1660-MF-058-0-04 Page 1

Injection Firmware Version 4.04 (30Jun05)

Figure 4. Injection Card A-60136

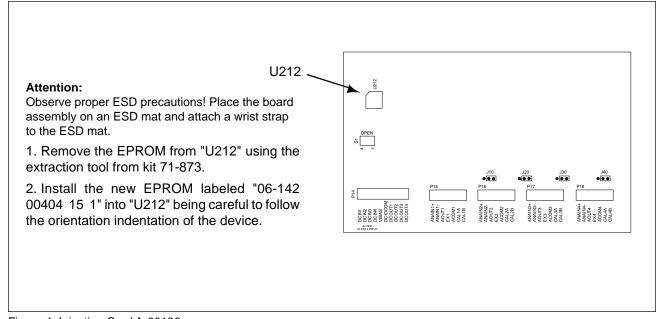
This firmware is a correction of FPGA configuration in sampling of reference frequencies. The problem demonstrate itself in different date codes of Xilinx FPGA, E21S-2019. With a large change in input voltage, shifts as high as 30 mV have been observed. A shift of this size is then removed in approximately 10 seconds.

This firmware changes the powerup/ready/code size and corrects the calibration relay to x08 vs x04.

This firmware increases the "wait states" for control bus memory access in order to correct a problem observed on some systems with large bus loadings. In one case, the problem exhibited itself as a "control dual port ram error." In another case, the system showed inconsistent memory values for large data block transfers.

To facilitate factory testing, the "control fault" is momentarily set on powerup (allowing for verification that the control fault LED is operational).

This firmware first shipped in A-60136 boards and is compatible ONLY with A-60136 boards. Version 4.00 was written to support the faster operation (50 MHz) of the A-60136 boards and is the first release of the injection firmware. This firmware (and the A-60136 boards) are compatible with MACO DS/RS systems.
